Moolarben Coal Complex UG4 Ancillary Works Modification

Modification Report

GROUNDWATER REVIEW

Moolarben – UG4 Modification – Review of Groundwater Effects

Figure 1

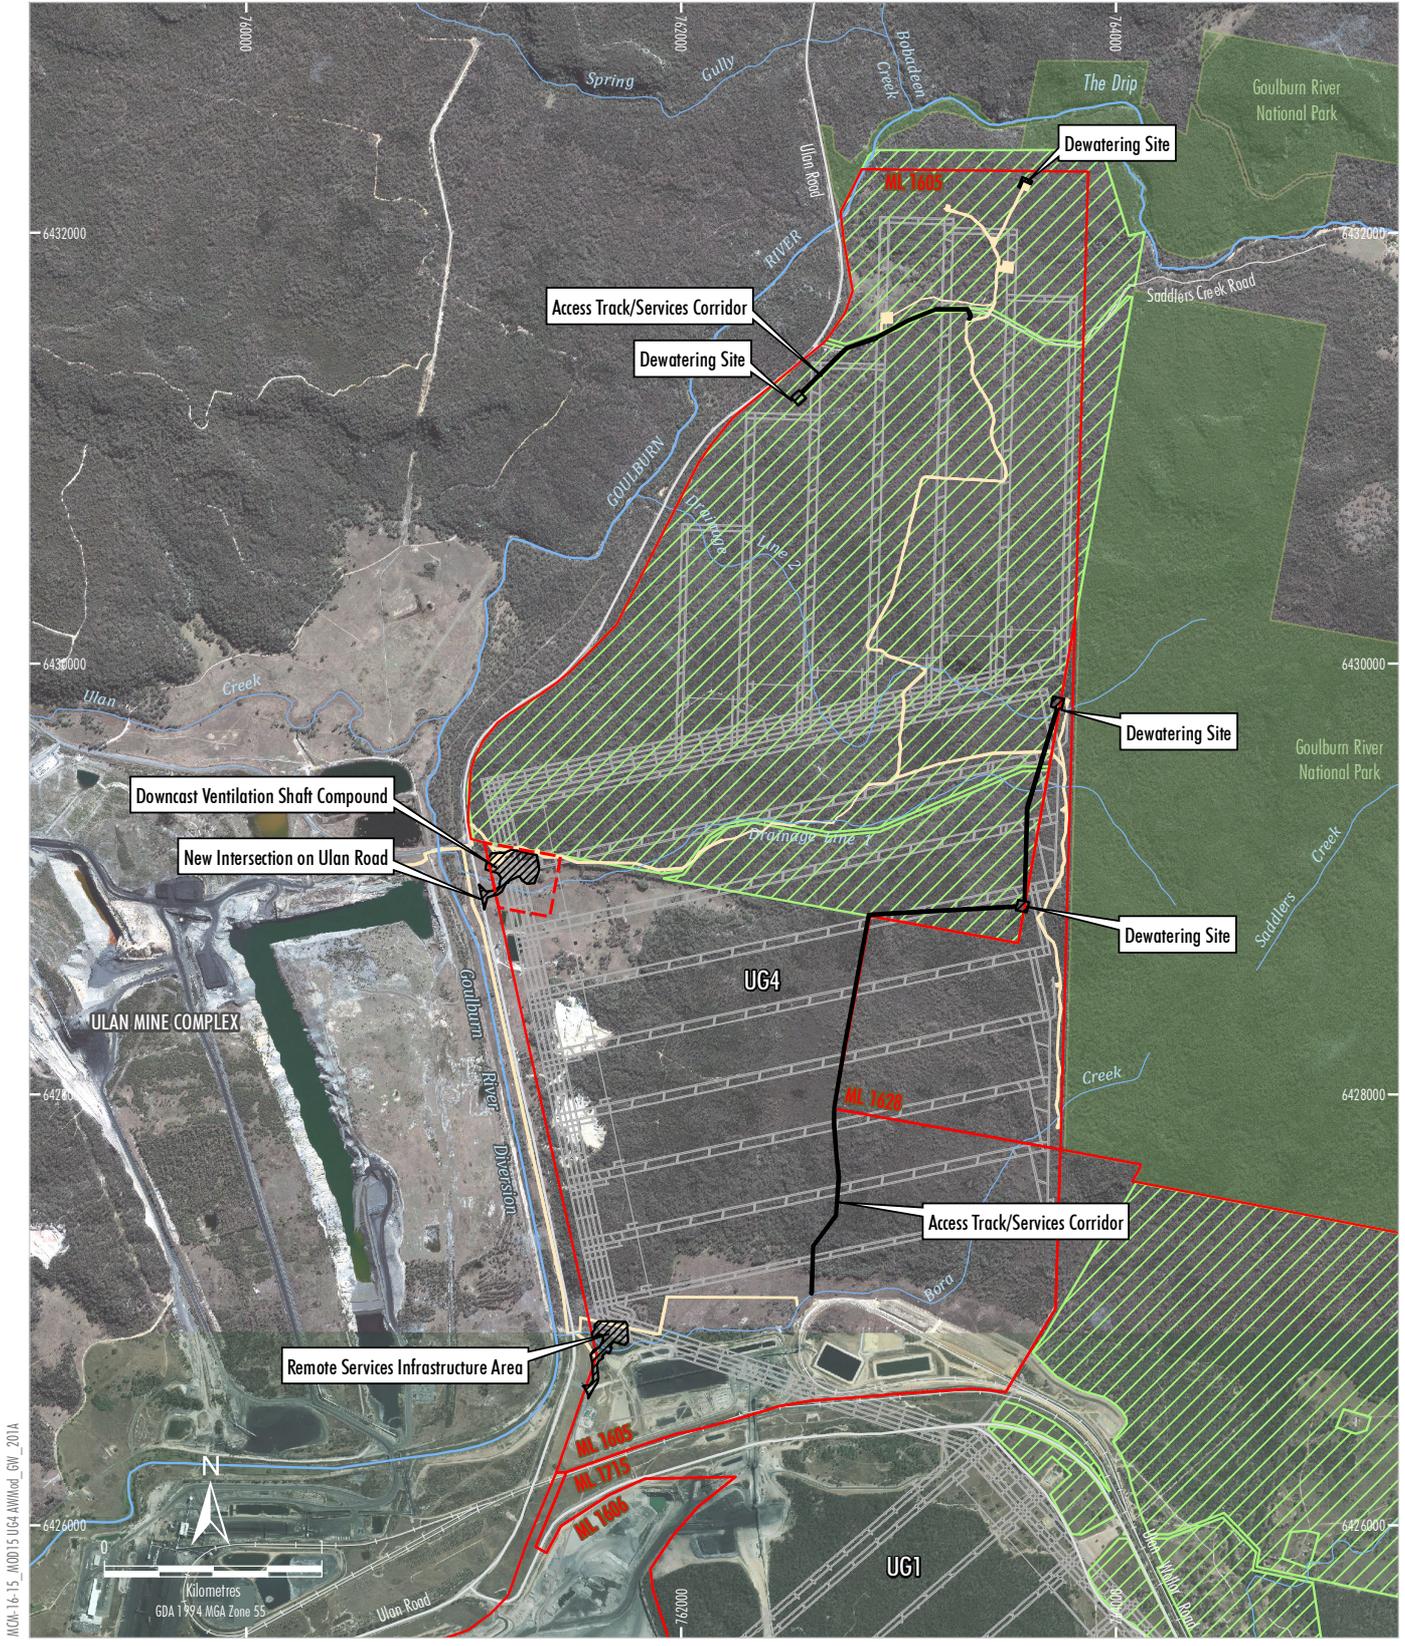
The extent of additional disturbance would be within the indicative surface infrastructure area shown on **Figure 1**.

The current proposed Modification would involve, inter alia, minor adjustments to the borefield and pipeline layouts, and as a consequence some additional surface disturbance for mine dewatering infrastructure. However, the Modification would not alter the overall operation of the dewatering and water supply borefield, and there would be negligible change to its groundwater impacts.

The proposed changes with the Proposed Modification are shown in black on **Figure 1**. The changes include the following:

- New intersection on Ulan Road and downcast ventilation shaft compound;
- Modified access track, services corridor and dewatering bore location (NW corner of UG4);
- Small extension of the dewatering bore site (N of UG4);
- Relocation of 2 dewatering sites on E side of UG4, and new access track connecting these sites to the main Moolarben infrastructure area south of Bora Creek;
- Remote services infrastructure area near SW corner of UG4.

In summary, construction and use of the above proposed surface infrastructure would not change the previously assessed and approved impacts of the UG4 mine on groundwater resources.
